SUBJECT: NuScale Power, LLC Response to NRC Request for Additional Information No. 401 (eRAI No. 9447) on the NuScale Design Certification Application

Response to Request for Additional Information Docket No. 52-048

NRC Question No.: 03.11-19

Figure 3.7.3-1: **Cutoff View of Reactor Building to Depict Bioshields**

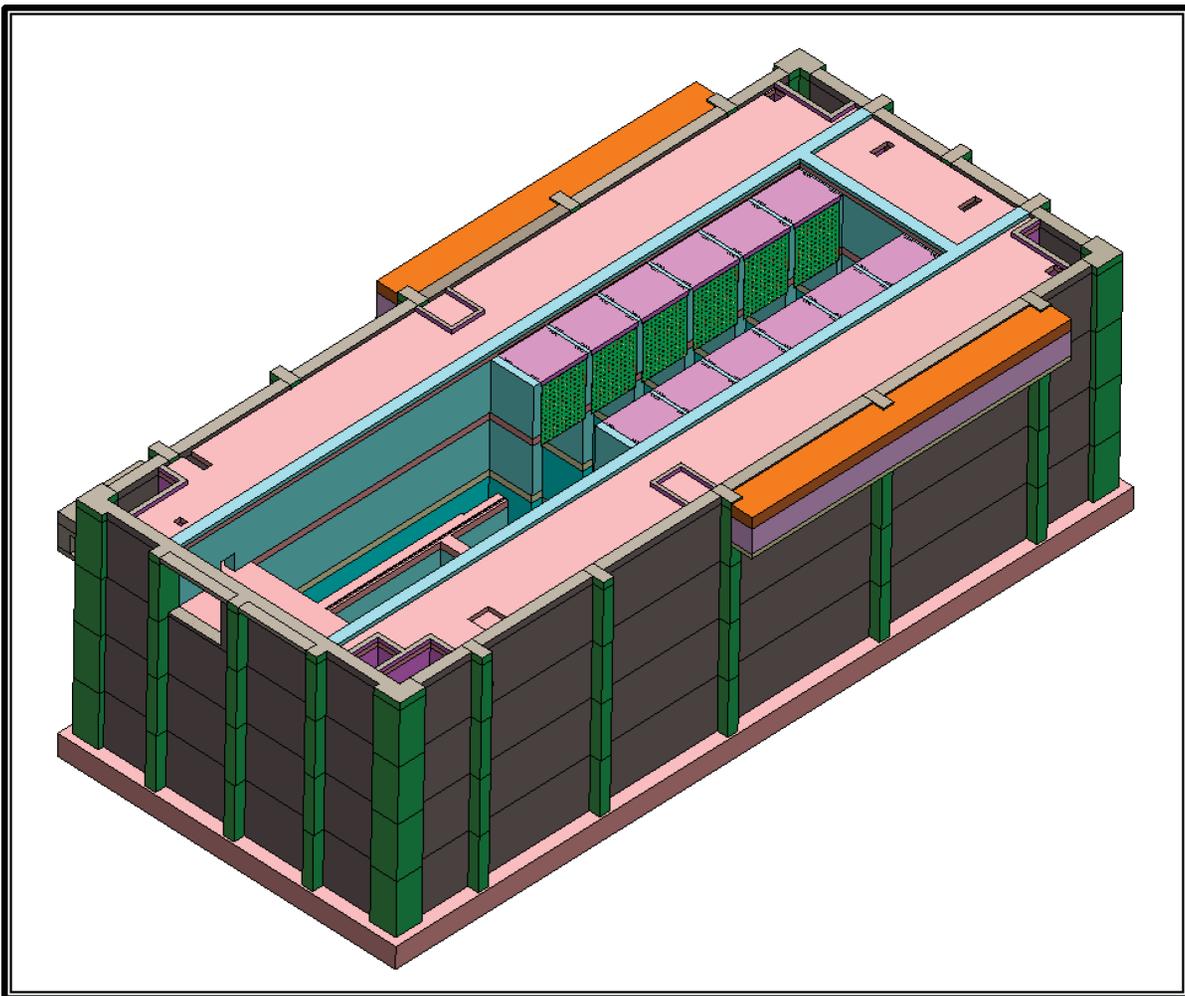
Each bioshield is comprised of a horizontal slab supported by the bay walls and a hanging vertical ~~face plate assembly~~ attached to the horizontal slab. The horizontal slab consists of ~~21.5~~23.5-in. thick reinforced 5000 psi concrete, ~~with a 2-in. layer of high-density polyethylene on the top.~~ The concrete ~~is and high-density polyethylene are~~ encapsulated in 1/4-in. ~~stainless~~ steel plates for a total thickness of two feet. The vertical ~~plate assembly~~ is constructed of a stainless steel tube framing system and ~~stainless steel face plates~~ series of radiation panels. ~~The radiation panels are comprised of 4-in. borated HDPE panels with 5 percent boron content encased within steel panels.~~ The vertical ~~plate assembly~~ is vented for heat removal during normal operation ~~via two fire and pressure-rated louvered vents, and as well as~~ heat and pressure mitigation in the event of a high energy line break and slow leak, high temperature event above the NPM ~~via hinged pressure relief panels providing one-way ventilation.~~ The vents ~~are arranged on the vertical portion of the bioshield in a staggered manner, allowing for continuous ventilation of the operating bay~~ for normal operation are located two feet off the surface of the pool, with one vent on the left and one on the right side of the front face of the vertical portion of the bioshield. ~~The pressure relief panels cover the space between the vents for normal operation and all the way up the vertical face of the bioshield. A solid design is used as a representative weight for the structural analysis.~~

The bioshields are attached to the bay walls and outer pool wall using 1.5-in. diameter removable anchor bolts. Figure 3.7.3-1 shows six installed bioshields and Figure 3.7.3-2 shows a vertical faceplate.

Figure 3.7.3-4: In-structure Response Spectra Used for the Evaluation of the Bioshield Not Used

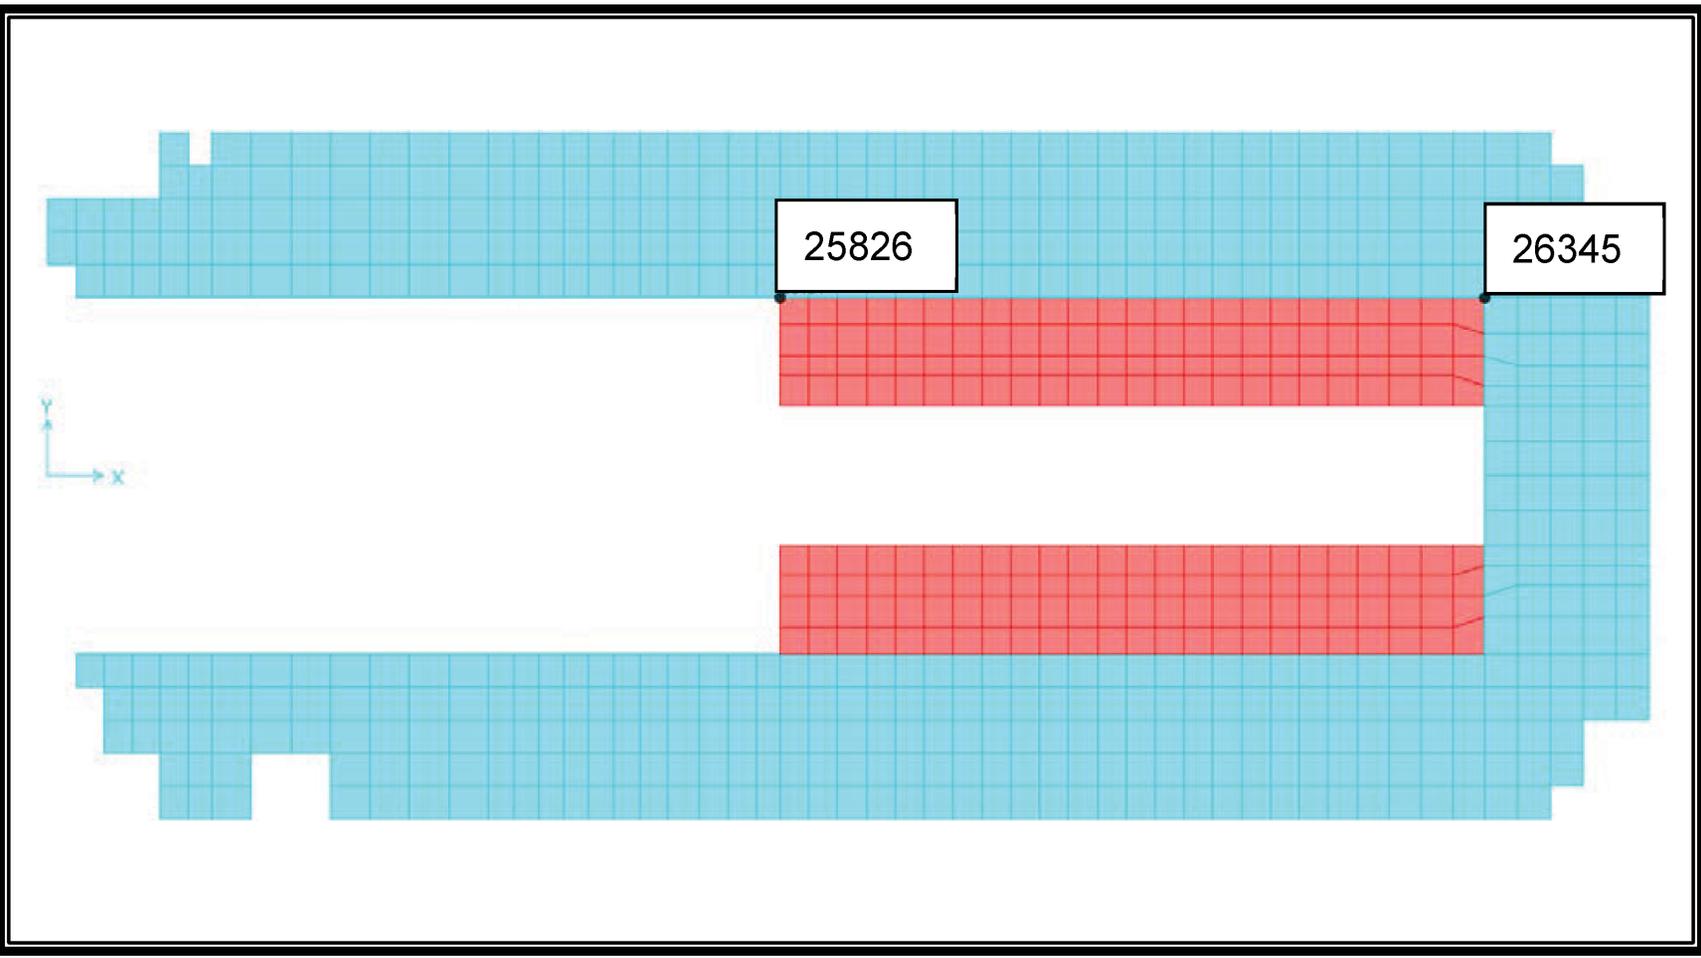
In-structure response spectra were developed for multiple locations in the RXB in Section 3.7.2. Two nodes from that model were selected to use for the design of bioshields. These nodes are shown in Figure 3.7.3-3. Plots of the ISRS at these nodes are shown in ~~Figure 3.7.3-4~~ [Figure 3.7.3-4a](#), [Figure 3.7.3-4b](#), and [Figure 3.7.3-4c](#).
